## STAFF RECOMMENDATION

1506 Boscobel Street

July 17, 2019

**Application:** New Construction-Infill

Figure 2: South side of 1500 block of Boscobel – arrow indicates subject lot

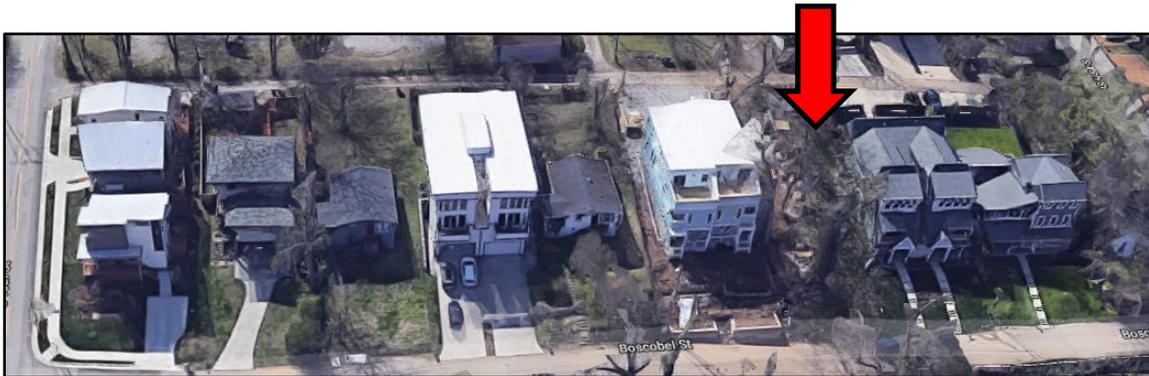
Because the 1400 through 1600 blocks of Boscobel Street do not have strong historic integrity, the design guidelines specify that infill in this area may be two-stories tall. Other houses on the block range from nineteen feet (19') to thirty-eight feet (38') tall. (Figures 2, 4 and 5). Staff finds that the height is appropriate in this case as the partial third level is set back significantly, as the immediate context contains comparably sized houses and as the immediate context contains little historic integrity.

Figure 7: Rear elevation

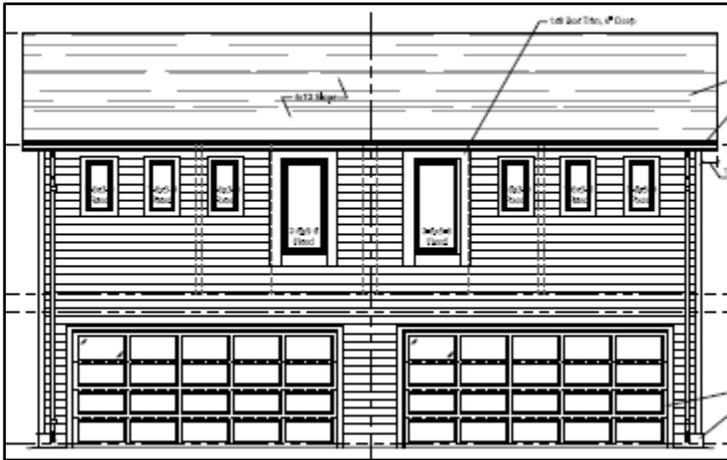
**Outbuildings:**

The applicant is proposing an attached garage on the rear elevation, at the alley.

Attached garages are not typically permitted in the overlay unless they are at basement level. However, in this case, Staff finds that it could be appropriate for several reasons. First, the lot is somewhat short, at one-hundred-twenty feet (120') deep; the slope of the lot

makes a detached outbuilding problematic; the narrowness of the street make street parking difficult on this block; and lastly, the lack of historic context on this block creates a condition where an attached garage would not be out-of-place.

For these reasons, Staff finds that the proposed attached garage may be appropriate in this specific instance.
